Access Compliance Report

Public Rights-of-Way

(Curb Ramps)

Intersection ID: 14982	Main Street: ARENA_BV	Cross Street: COLISEUM_DR	Location: NE
ADA ID: BFE61FF1152E	Ramp Type: Perp	Initial Pass/Fail: Fail	Overall Compliance: No
Severity Score: 35			
Codes/Mitigation Info/Possible Solution		Field Measurements/Component Compliance

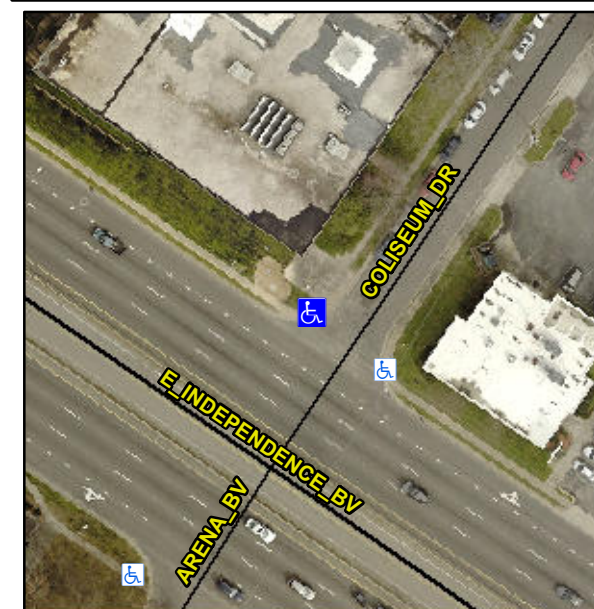
Not Found, R304.5.1, R304.2.2, R304.5.3

Compliance	Description	Data	Compliance	Description	Data
N/A	Ramp Length (in)	48.0	No	Ramp Slope (%)	15.0
No	Ramp Width (in)	44.0	No	Ramp XSlope (%)	3.1
N/A	Flare Type LT	N/A	N/A	Flare Type RT	N/A
N/A	Flare Slope LT (%)	N/A	N/A	Flare Slope RT (%)	N/A
N/A	Flare Traversable LT?	N/A	N/A	Flare Traversable RT?	N/A
N/A	Landing Length (in)	N/A	N/A	DWS Provided?	N/A
N/A	Landing Width (in)	N/A	N/A	DWS Contrast?	N/A
N/A	Landing Slope (%)	N/A	N/A	DWS Length (in)	N/A
N/A	Landing X Slope (%)	N/A	N/A	DWS Full Width?	N/A
N/A	Landing Curb? (Y/N)	N/A	N/A	DWS Offset (in)	N/A
N/A	Shared Landing?	N/A			
N/A	Gutter Ponding?	N/A	N/A	Gutter Slope (%)	N/A
N/A	Gutter Lip Ht (in)	N/A	N/A	Gutter X Slope (%)	N/A
N/A	Painted X Walk1?	No	N/A	Painted X Walk2?	N/A
	X Walk 1 Direction	To SE		X Walk 2 Direction	N/A
N/A	X Walk 1 Width (in)	N/A	N/A	X Walk 2 Width (in)	N/A
	X Walk 1 Slope (%)	2.1		X Walk 2 Slope (%)	N/A
	X Walk 1 X Slope (%)	2.0		X Walk 2 X Slope (%)	N/A

Remove & Replace Entire Ramp.
